# Architectural Review and Historic Preservation Board Agenda Report

File: AR 18-16

RE: Architectural Review 18-16 (Stoble Coffee)  
418 Broadway Street, APN 004-142-002

**SOUTH ELEVATION**

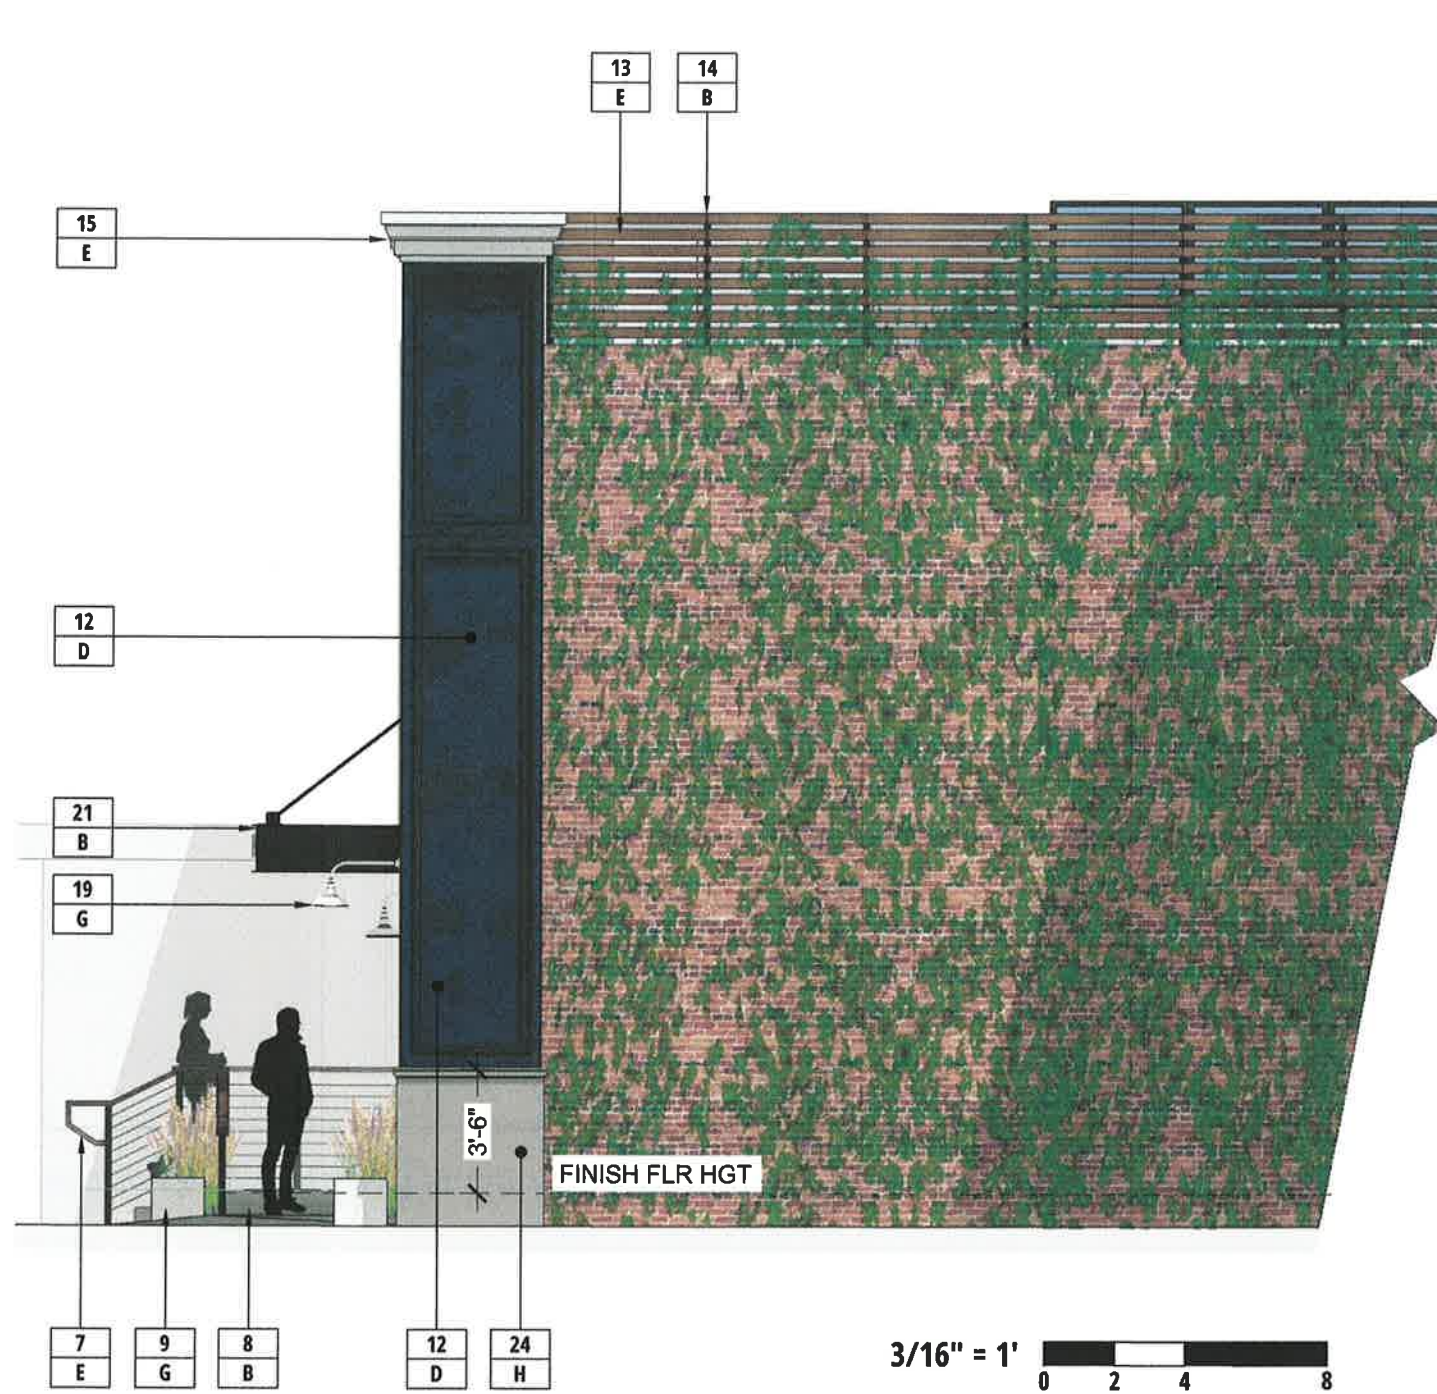
The roof is proposed to be redeveloped into an outdoor deck and seating area. The perimeter of the roof deck would feature three-foot, six-inch steel guardrail posts with steel cable railing. There will be two roof access penthouses that would have metal cladding with aluminum storefront windows. The deck and seating area would be covered by a steel trellis frame with wood shade slats and decorative string lights (see Roof Deck Perspective, **Attachment J**). Roof-mounted utilities would be located on the west half of the roof and screened by steel posts with a wood screen (see South Elevation, **Attachment K**).
